MUNCIE POWER PRODUCTS

Product Bulletin #00087

Subject: TITAN® MC1 Valve Change

Date: Effective April 25, 2020

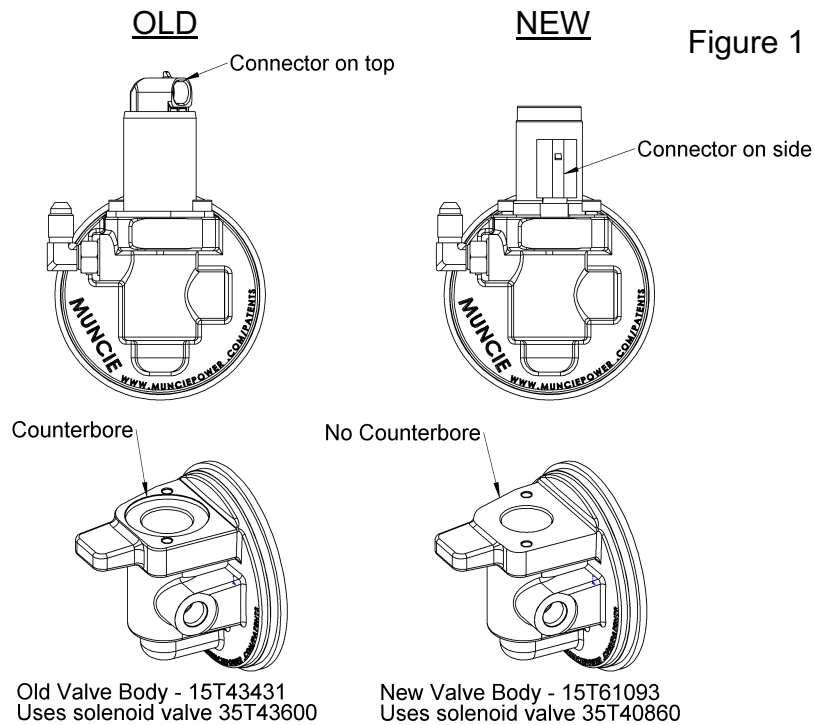
The TITAN® MC1 PTO will now be equipped with a new on/off solenoid valve and valve body. The valve used will now be the same as used on the CS24 family of products.

The new valve cannot be used with the old valve body. Plumbing for the unit remains unchanged. Differences between the old valve and new valve are shown in Figure 1 below.

- 35T40860 - 12V Solenoid Valve – On/Off
- 35T40864 – 24V Solenoid Valve – On/Off
- 19T40859 – Solenoid Valve Mounting Cap Screws
- 15T61093 – Valve Body – On/Off
